REMARKS

Title: Thermal Transfer Interface System And Methods Inventors: Christian Belady & Eric Peterson -- Docket: 10018060-1 Attomey: William J. Streeter (970) 898-3886

FIG. 4

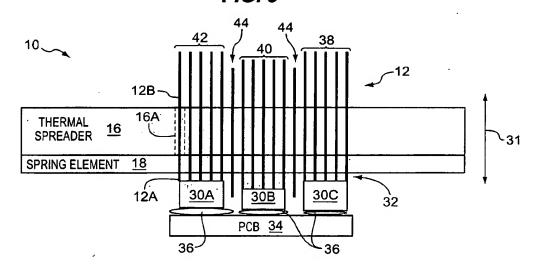
FIG. 4 is amended to show cross-hatching on spring element 60, to "show" the material of spring element 60.
